Section 4.55(2) modification to DA/1157/2016/H (PPSSCC-102)

Development Application DA/295/2020 (Stage 4) (PPSSCC-103)

657-661 Victoria Road & 4-6 Wharf Road, Melrose Park

ATTACHMENT 1

Proposed Level 1 Plan with new Lobby lounge area

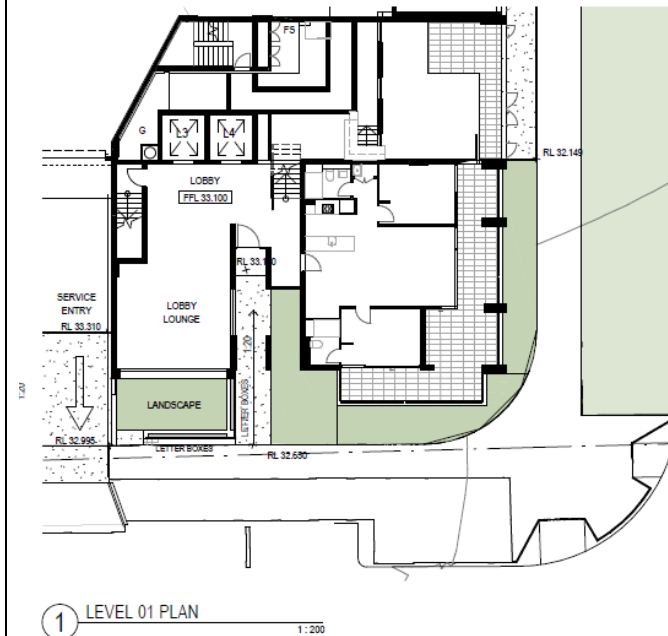
- AJC have provided a revised layout for Unit 2101 (**Attachment 2**) which replaces the unit as a 2 storey townhouse with a new improved lobby at Level 1 and a studio apartment at Level 2 (accessed via a stair from the lobby level).

- The proposed amendments provide a superior design outcome for the following reasons:
 - the studio apartment does not include windows on the service ramp side to ensure high levels of amenity

- the studio apartment is located above the proposed truck entry
 - the re-designed apartment provides an additional 16m² of deep soil landscaped area (previously private open space for the townhouse)

- the re-design creates a 8 metre high lobby space with opportunity for natural light from highlight windows on the western elevation
 - the inclusion of an additional studio apartment provides more affordable housing choice in the development

- On this basis, we request Draft Condition 53 be amended as detailed in Attachment 1.

Proposed new studio apartment 2101 at Level 2

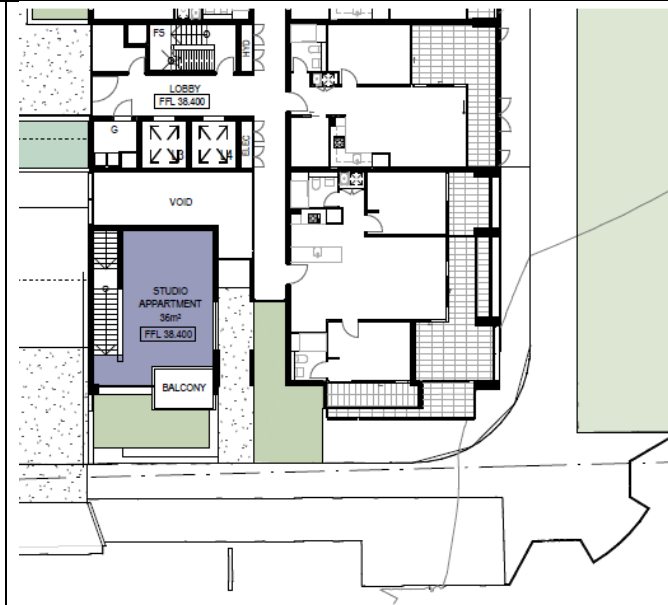
The amended plan provides a superior design outcome that:

- addresses the objectives of the DA condition
- provides for an improved amenity outcome for unit 2101
- creates a superior entry lobby for all apartments in Building 2

The revised layout for Unit 2101 is supported by the Acoustic Consultant confirming that the amended layout of the unit complies with the required internal noise levels (Attachment 3).
